Glendell Mine Modification 6

**Submissions Report
Mt Owen Pty Limited
April 2026**

3172GLEN 008 - Current Status of Rehabilitation.aprx

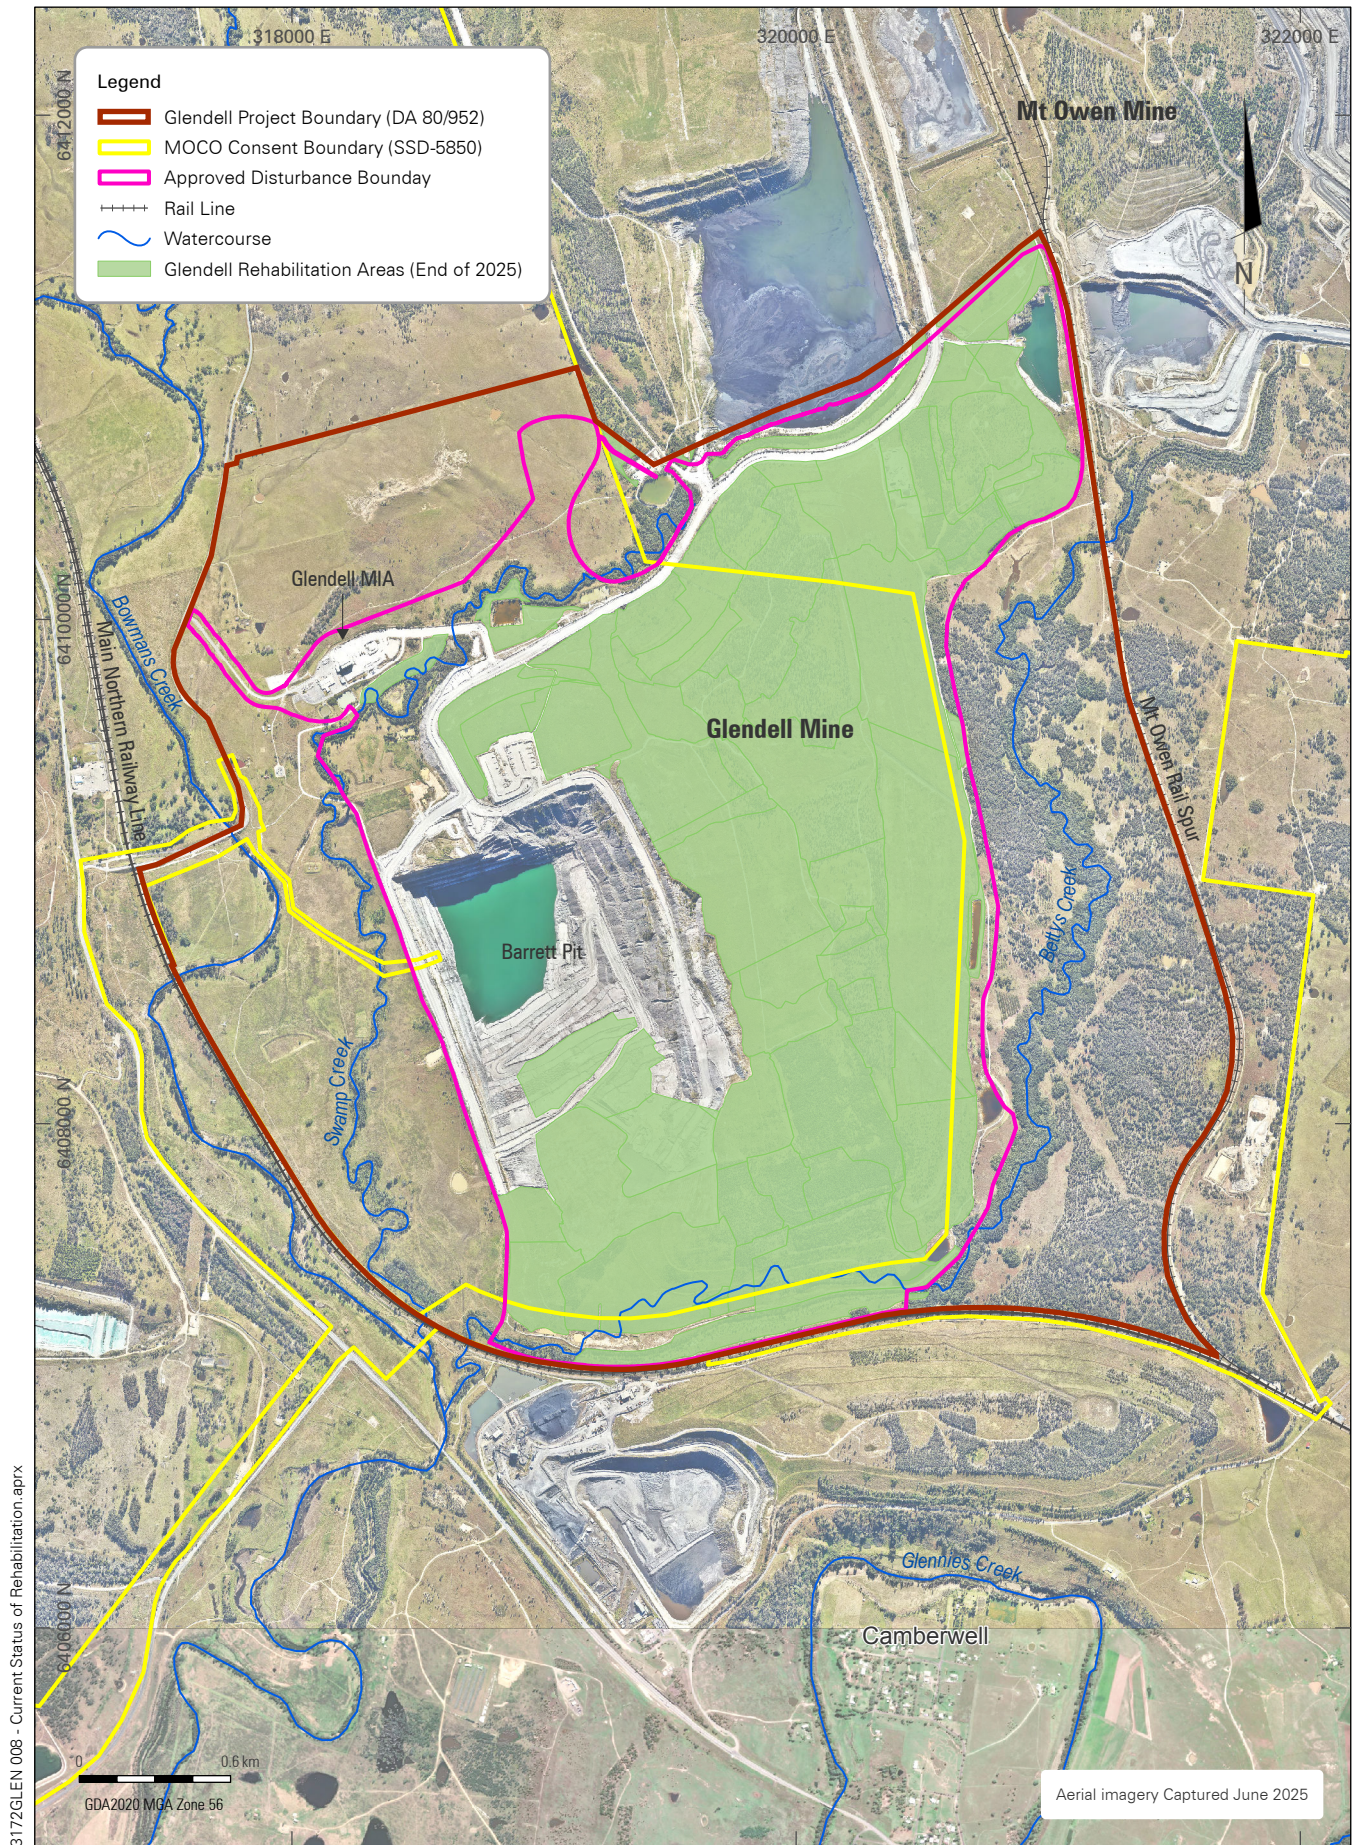
Submissions from NSW Resources and CS3 noted the proposed continuation of existing approved activities at the MIA until the end of 2039 and sought further detail on whether there were any opportunities to decommission infrastructure and rehabilitate the area prior to this date.

Figure 3 shows that rehabilitation at Glendell is well advanced, with approximately 541 ha of rehabilitation established to the end of 2025. This substantial progress should provide confidence in the capability and commitment of MOPL to continue the delivery of rehabilitation outcomes in accordance with the approved rehabilitation objectives and completion criteria.

Indicative Rehabilitation from 2035 - 2037

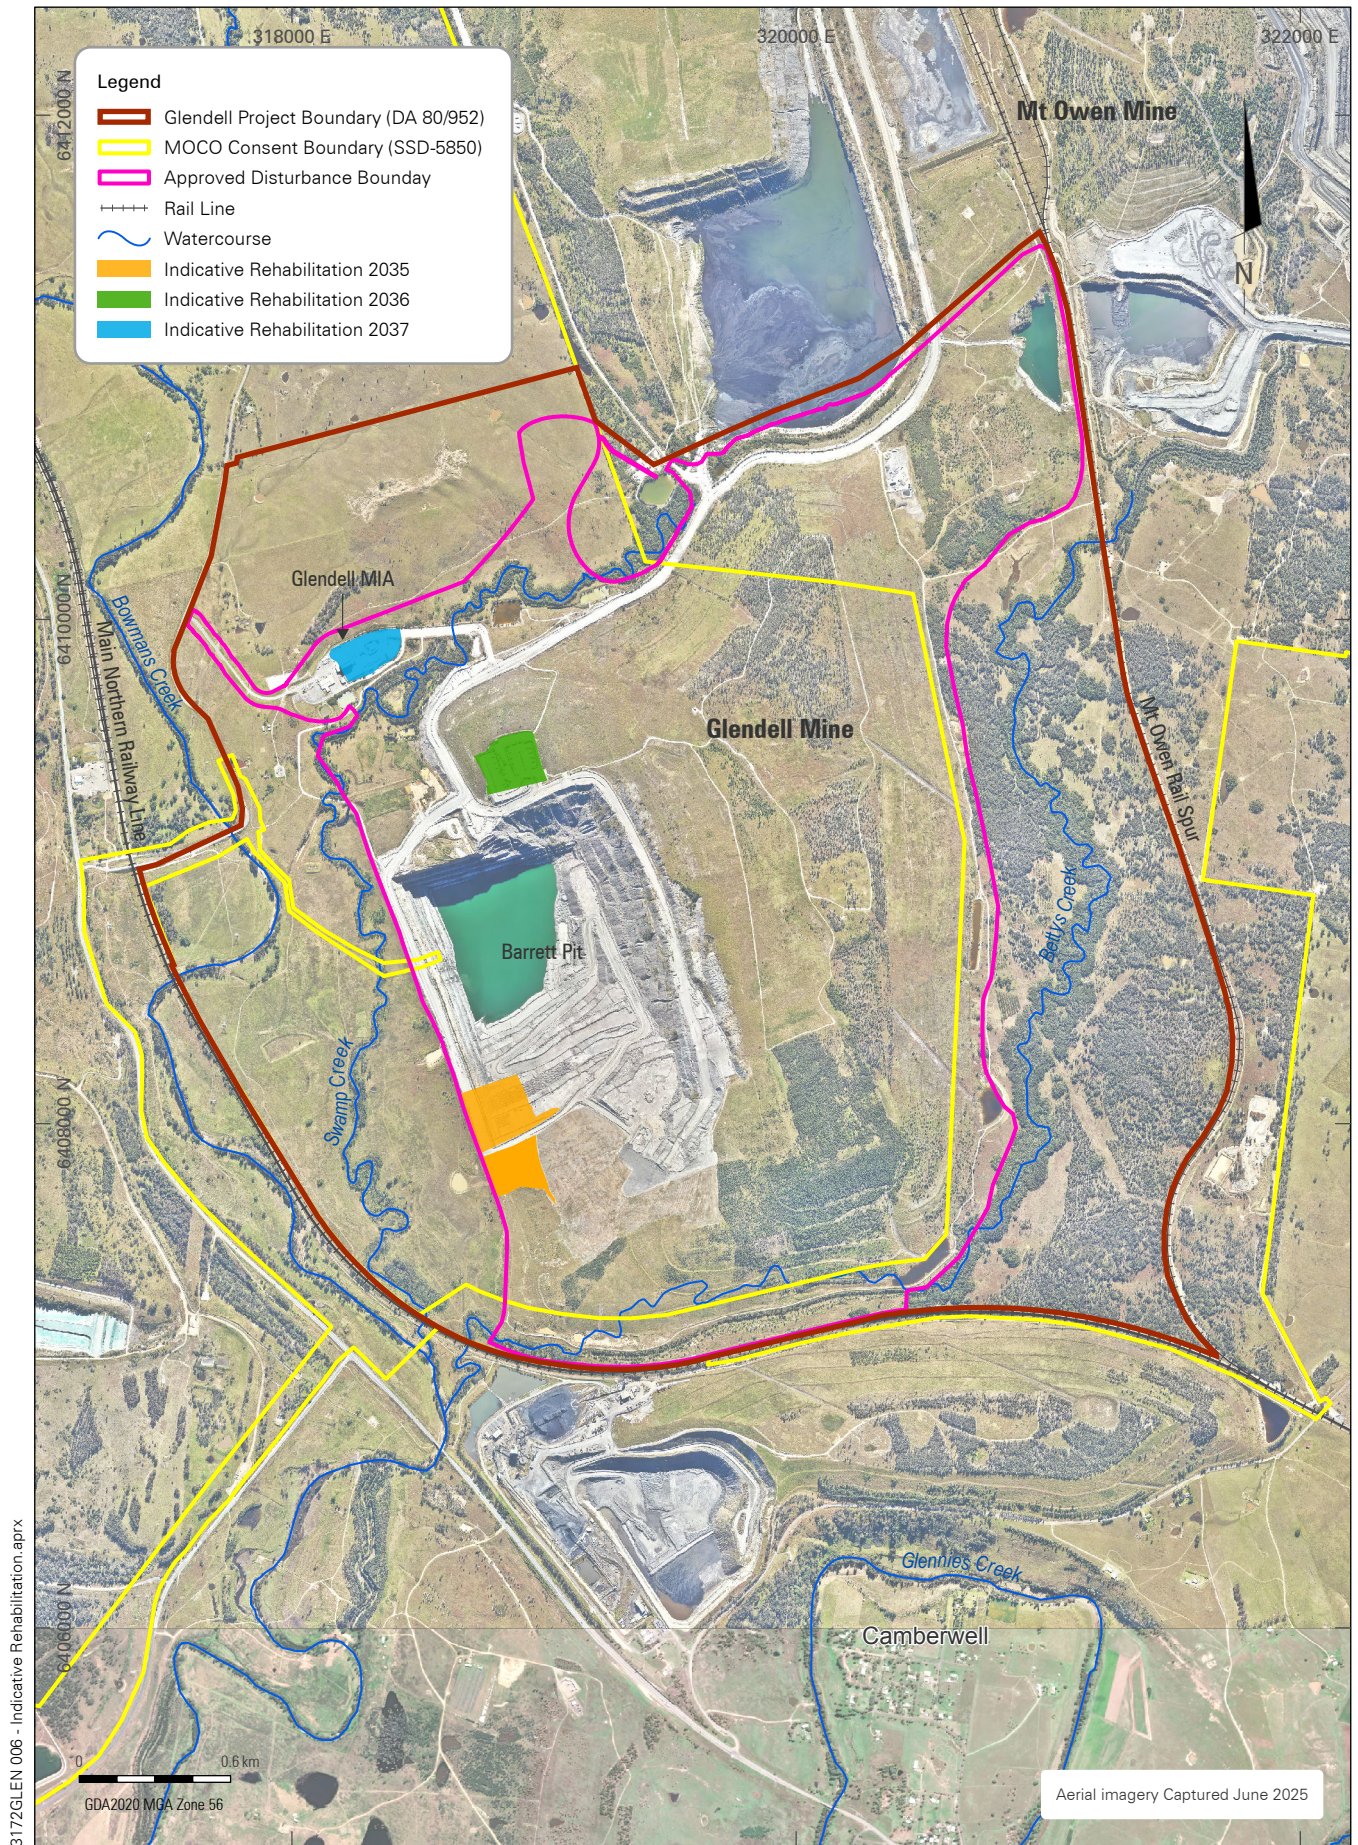
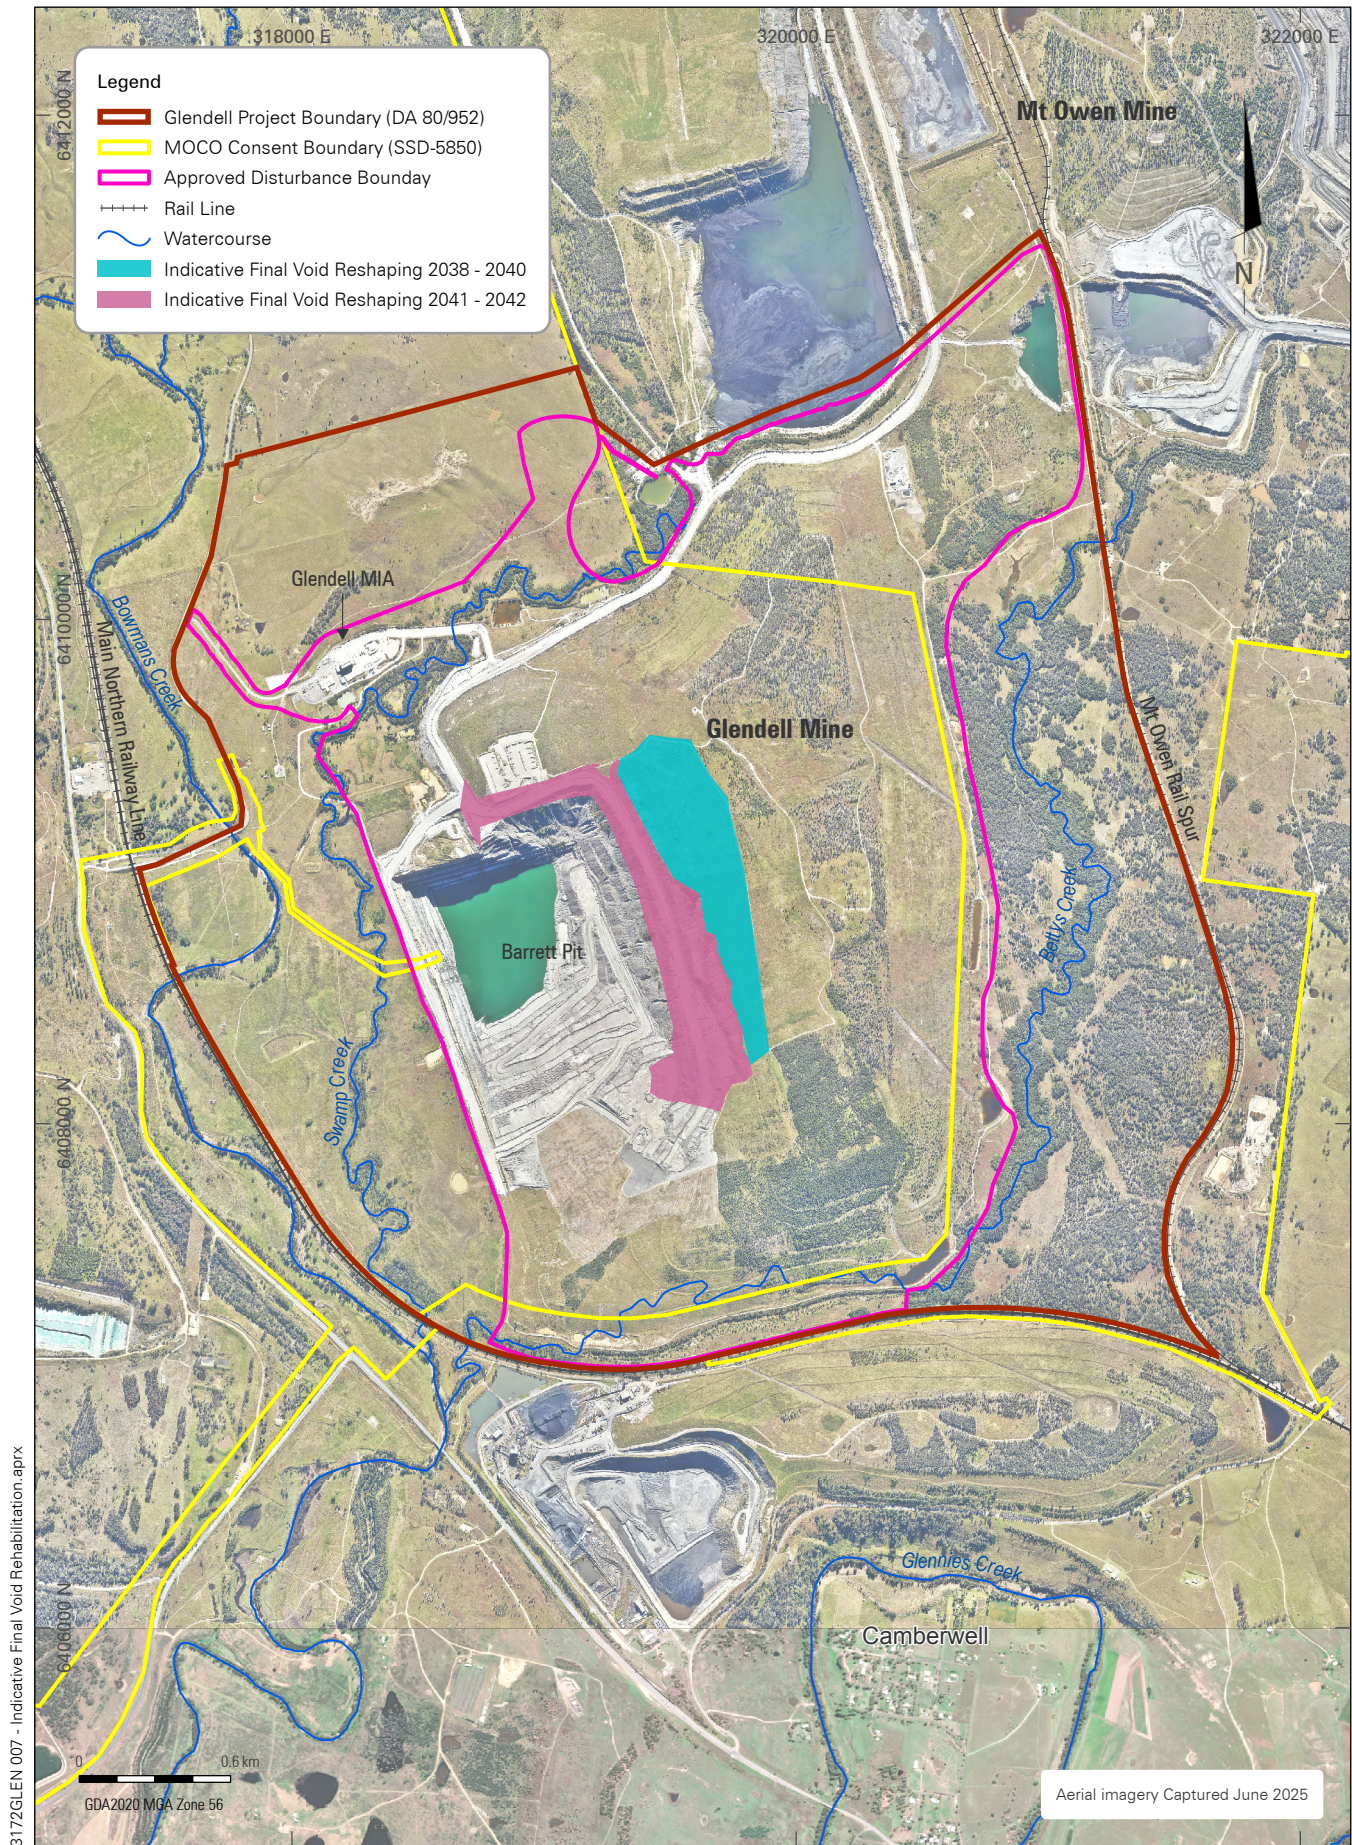
NSW Resources noted that a description of the revised life of mine rehabilitation schedule should be provided (including for those works required beyond 31 December 2039 to achieve final land use), to ensure that Glendell rehabilitation is undertaken as soon as practicable.

NSW Resources and CS3 also noted the need for further justification on the proposed delays in the rehabilitation of the OEA adjacent to the Barrett Pit void until after December 2039, along with an updated plan showing the areas to be rehabilitated after this date.

Consistent with the requirements of SSD-5850, demand on MGO operational and site-based resources is expected to reduce from December 2037. This reduction is anticipated to create additional capacity to support the acceleration of progressive rehabilitation and closure implementation. An indicative schedule of progressive rehabilitation activities for Glendell during the period from 2035 to 2037 is shown in **Figure 4** (noting that this is indicative only and is subject to change depending on operational requirements). As noted in **Section 3.2.1**, MOPL will continue to review rehabilitation outcomes and complete annual performance reporting during this time, in accordance with the requirements of the Mining Regulation.

From 2038, MGO proposes to commence shaping of the upper section of the eastern slope of the final void. This area requires reworking to achieve the approved slope criteria and final landform design requirements, and its rehabilitation would represent a further important step toward establishing the final landform.

Subject to stored water levels, operational requirements and the ability for the Barrett Pit dewatering to commence prior to December 2039 (see **Section 3.2.1**), MOPL may also be able to commence preparation of the final Barrett Pit rehabilitation on the eastern slope of the final void from 2038, with shaping of the lower section of the eastern slope to achieve the final landform from 2041 – 42, as conceptually illustrated in **Figure 5**. This demonstrates that MGO is actively identifying opportunities to bring rehabilitation forward where feasible.

Figure 1 - Northern wall and Verdelho fault interactions

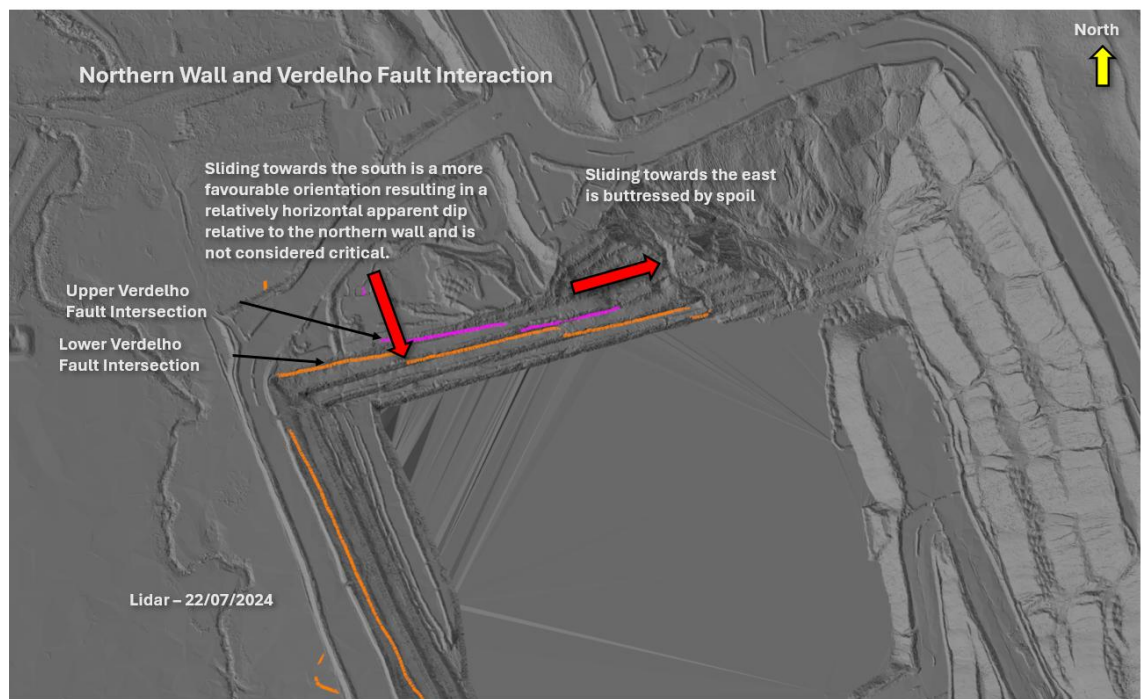
- › The presence of faulting in the northern highwall of the Barrett Pit and potential interactions with Modification-related seepage within the weathered zone; and
- › That further assessment of geotechnical / hydrogeological interactions is required to address stability risks associated with the storage of water in the Barrett Pit is required.

For the northern wall -

- The fault orientations relative to the northern wall are considered more favourable and buttressing support provided by previously placed spoil restricts the development of any deep-seated fault sliding mechanisms sliding towards the east. Faulting sliding towards the south is not considered critical due to the relatively sub-horizontal apparent dip and shallow position of the fault relative to the overall pit slope wall.
- The hydrogeological impacts on fault strength and integrity are considered to have minimal influence relative to the passive support provided by the adjacent mine spoil and favourable fault orientations.
